NRC Resolution of Facility Comment

Facility Comment on Q57

Question 57

NSA Position Control Group On / Backup Heaters in Auto

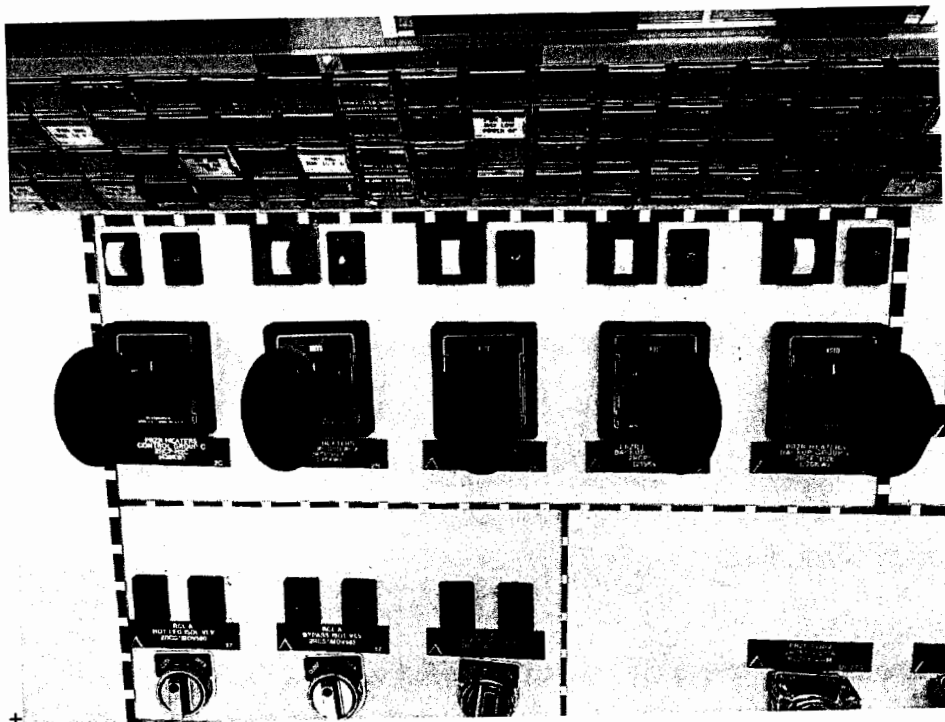
Given the plant conditions in the stem of the question (specifically the 8% PRZR level insurge), the Proportional heaters would remain ON and deenergized (benchboard red light illuminated but no output based on the 42% output of 2RCS-PK444) AND the Backup heaters would be ON and energized (benchboard red lights illuminated due to the 8% PRZR level insurge). See attached images reflecting NSA and conditions after the 8% PRZR level insurge.

If the candidate approached the question strictly focusing on the Proportional heaters still being ON, then answer "B" is correct.

If the candidate approached the question focusing on which heaters were energized, then "C" is still a correct answer.

Facility comment accepted, two correct answers accepted. Five applicants missed the question. The examiner reviewed documentation provided by the facility, exam bank questions for this system, and the system lesson plan. All use the “energized” or “deenergized” terminology to describe whether or not the heaters are powered, and “ON” or “OFF” for breaker position.

NSA Position Control Group On / Backup Heaters in Auto

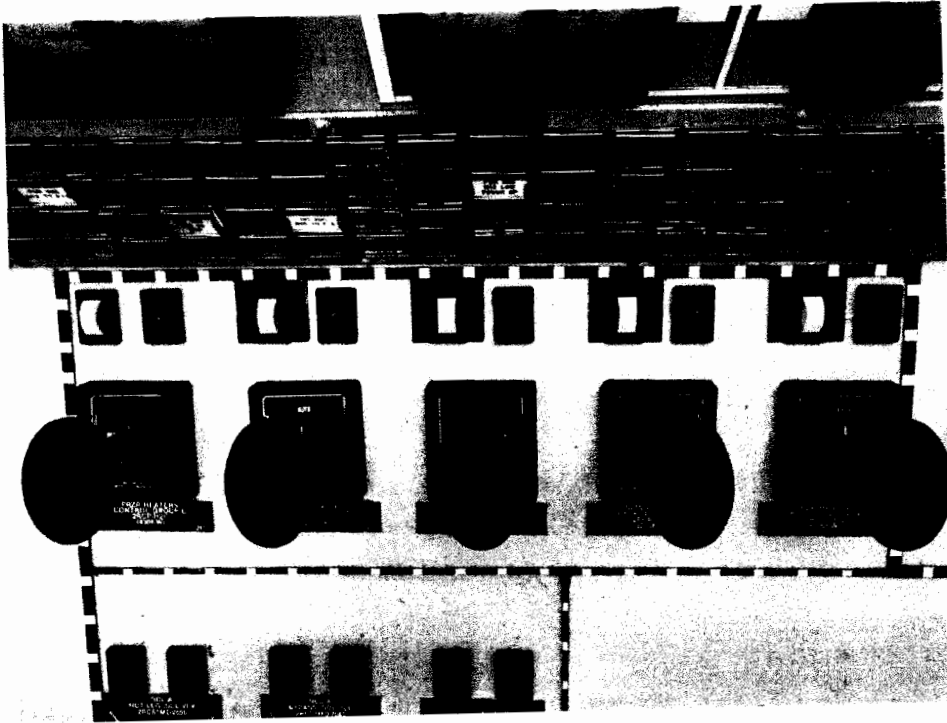
The normal switch position of the Proportional heaters is After-ON (see attached 2OM-6.3.C “Power Supply and Control Switch List”). In this condition, the benchboard red light is illuminated (see attached image).

Given the plant conditions in the stem of the question (specifically the 8% PRZR level insurge), the Proportional heaters would remain ON and deenergized (benchboard red light illuminated but no output based on the 42% output of 2RCS-PK444) AND the Backup heaters would be ON and energized (benchboard red lights illuminated due to the 8% PRZR level insurge). See attached images reflecting NSA and conditions after the 8% PRZR level insurge.

Heater Indication with greater than a 5% In-surge

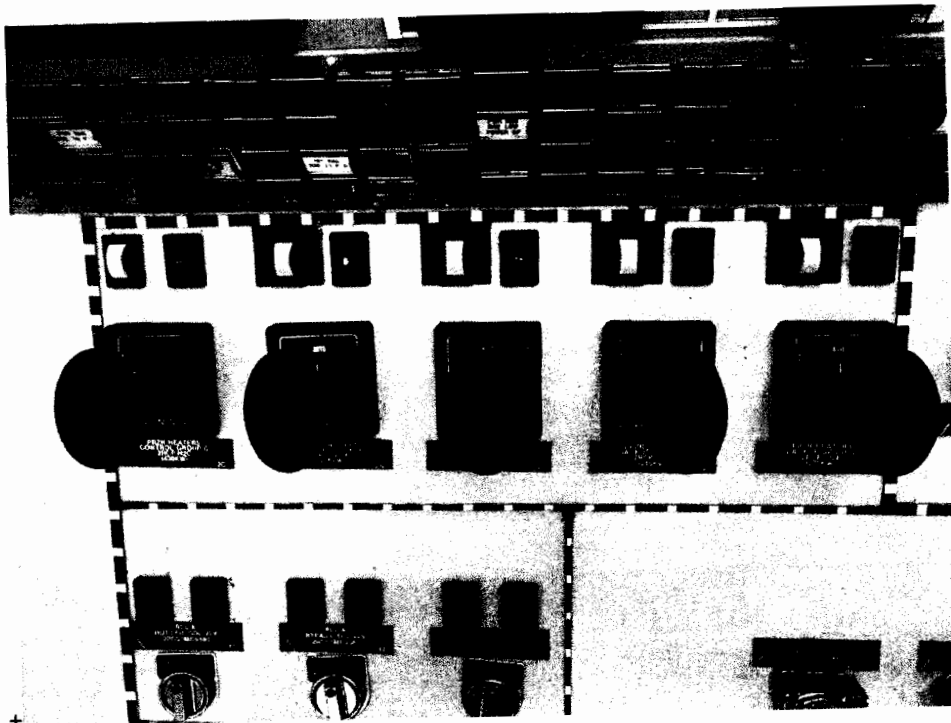
If the candidate approached the question focusing on which heaters were energized, then "C" is still a correct answer.
